**AGENDA
PLANNING COMMISSION**

Thursday, May 07, 2020

1. [Hillside Development Permit 14-02 \(HDP 14-02\) and Conditional Use Permit 14-08 \(CUP 14-08\); to allow construction of a new single family residence with an attached two-car garage for a total of 4,502 square feet at 9 Nathaniel Terrace, Lot 5 of Tract 54016, in the Stonegate development area](#)

2. [Modification to Administrative Hillside Development Permit 17-02: A request to modify the previously approved plans and elevations of the primary residence at 751 Oak Crest Drive](#)

BUILDING FRONT ELEVATION PROFILE COMPARISON

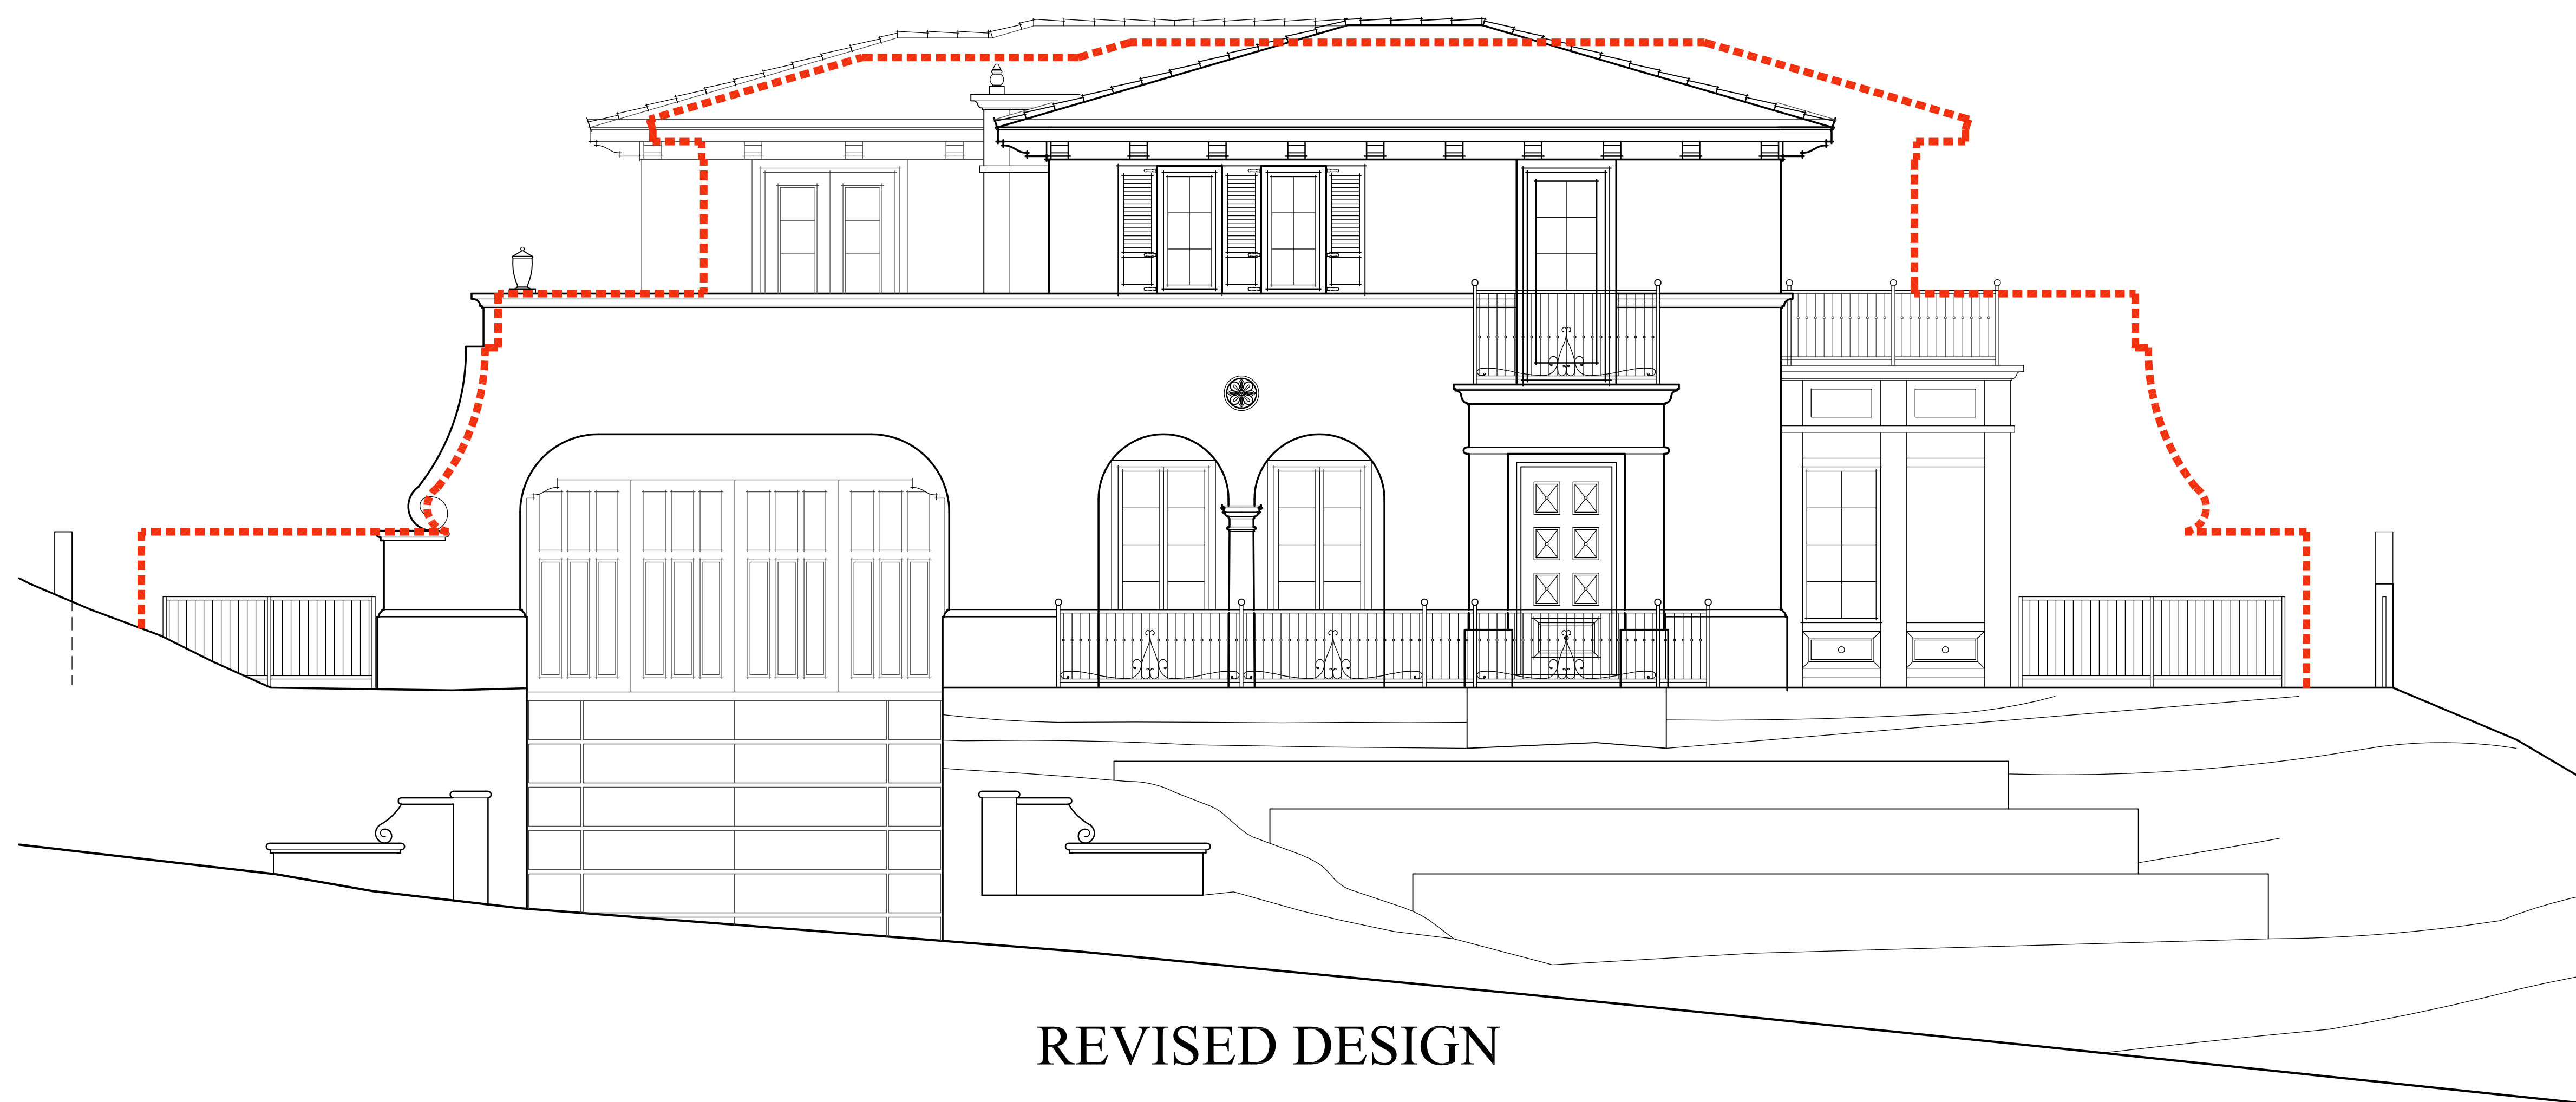
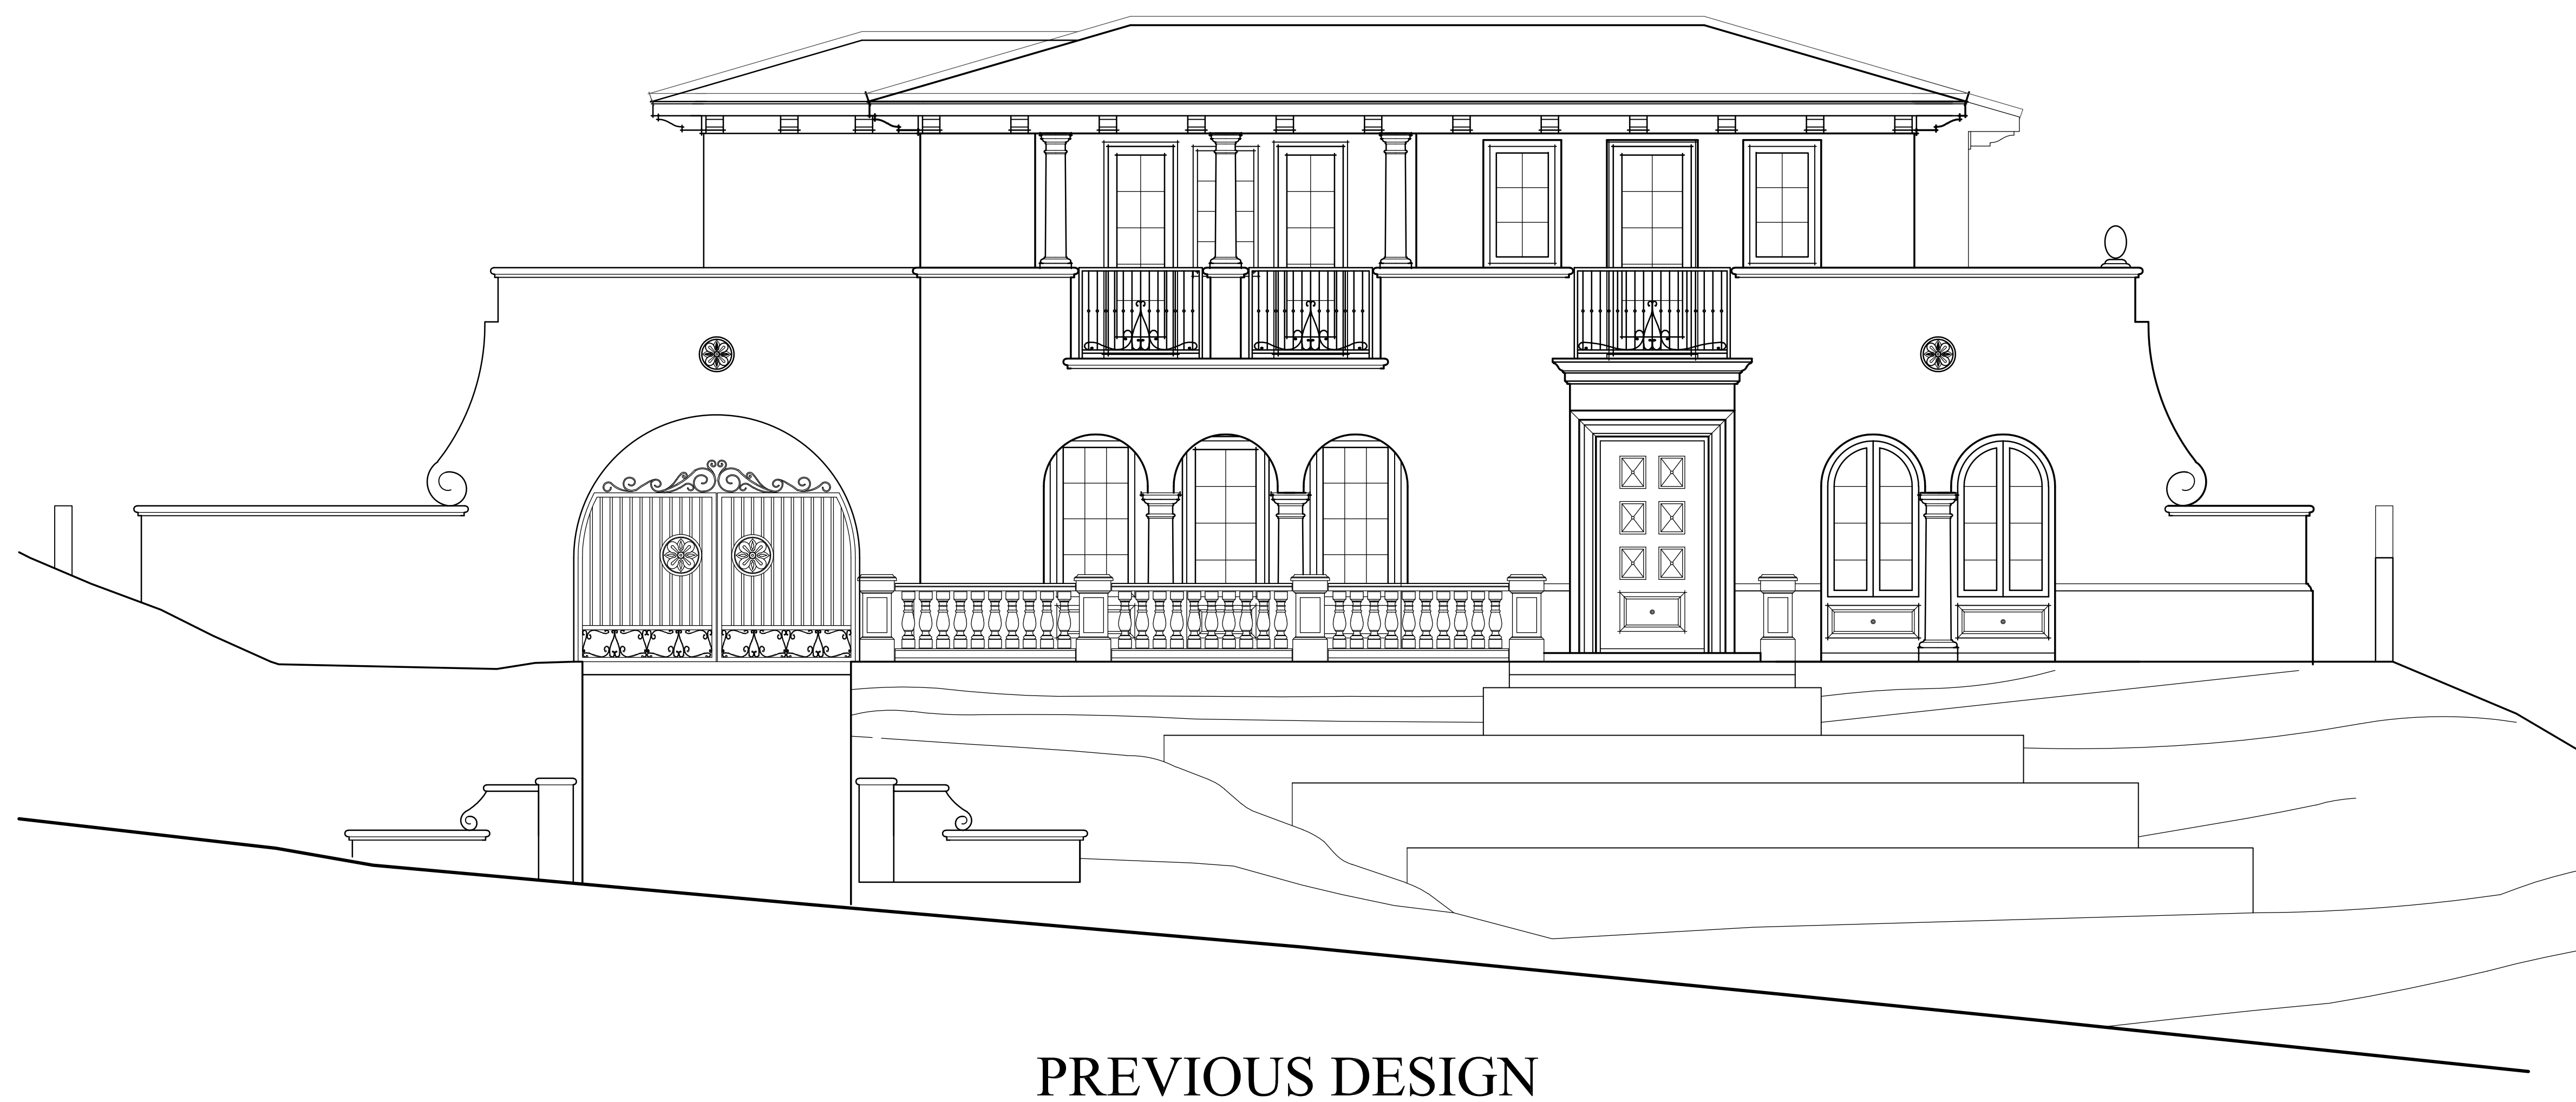
Commission Comment #2: Consider moving the mass to the north, reduce the stucco massing on the west facing building elevation, and study the prominent southwest corner with lower arms to the south.

- 1) Building front elevation/profile as seen on Nathaniel Terrace is narrower due to the reduced mass and shortened wing walls.
